WARRANTY
CAMPAIGN

No. **2001-1**

SUBJECT: Drive Pulley Calibration Label

YEAR	MODEL	MODEL NUMBER	SERIAL NUMBER
2001	Summit* 600	1758/1759/1760/1761	All

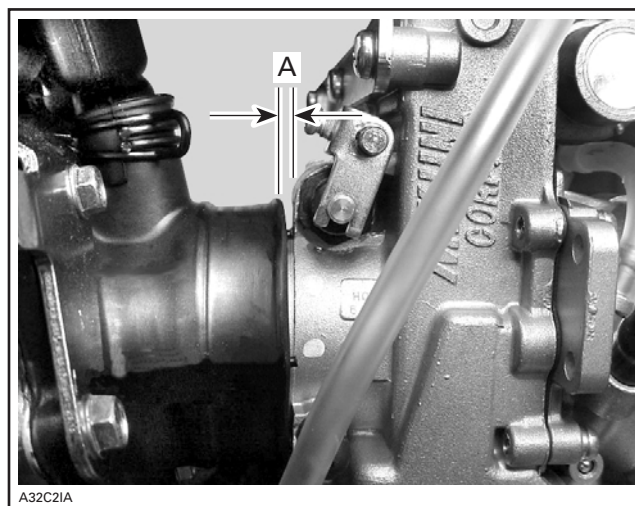
On some of the above mentioned snowmobiles, carburetors may not be properly installed into engine sockets.

As per following photo, make sure maximum clearance between engine sockets and carburetors does not exceed 1.5 mm (1/16 in).

A. Maximum 1.5 mm (1/16 in)

Loosen clamps.

Close up gap and tighten clamps while holding carburetor in place.

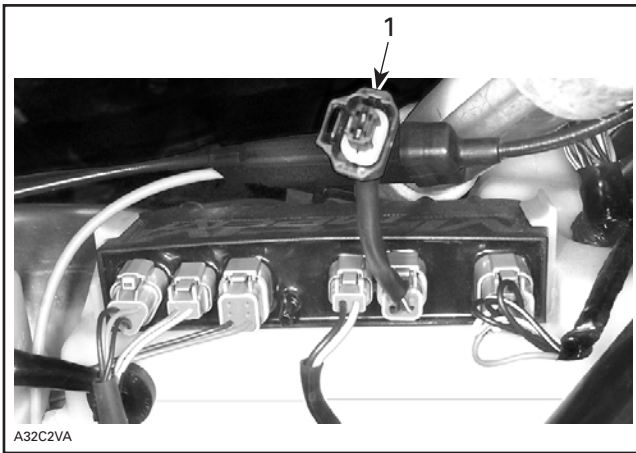
Replace carburetor assembly.

Note that new carburetor assembly is identified by a small punched mark directly after the word "Heated".

1. Fails to return completely
A. Surface to be worked on

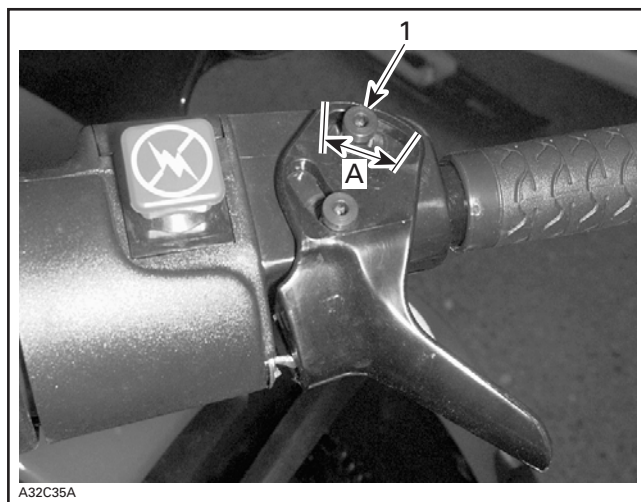
On the above-mentioned snowmobiles, throttle lever may fail to return from its first stage operation. If this occurs, it could lead to loss of speed control and possible collision with bystanders, a fixed object or another vehicle.

- A) If there is no resistance in the return movement and if there is a gap, then no further action is needed.**
- B) If even a slight resistance is noticed or felt and/or if gap cannot be seen, proceed with corrective action by enlarging upper first stage throttle lever slot; note that such a modification will give the needed gap.**

1. Screw to be removed

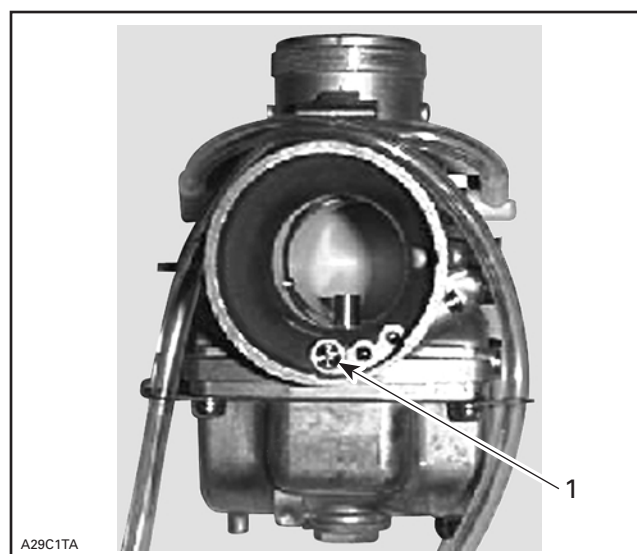
Vehicle may run rich and under certain conditions lack performance during low to midrange operation.

Make sure that carburetor idle circuit is vented to atmosphere and readjust air screws.

Remove air silencer. Make sure there is no screw in vented hole of idle circuit. If it is, remove and discard screw.

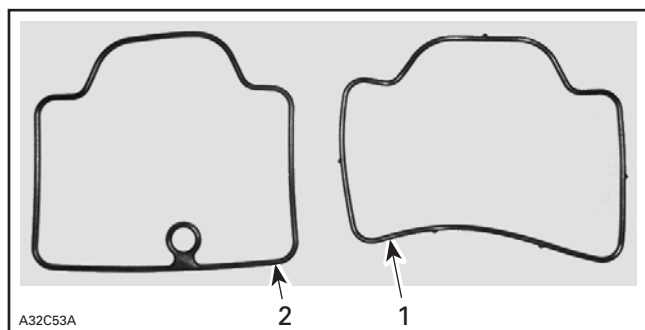
On some of the above-mentioned units, an excess amount of silicone applied on float bowl O-ring may plug carburetor jets.
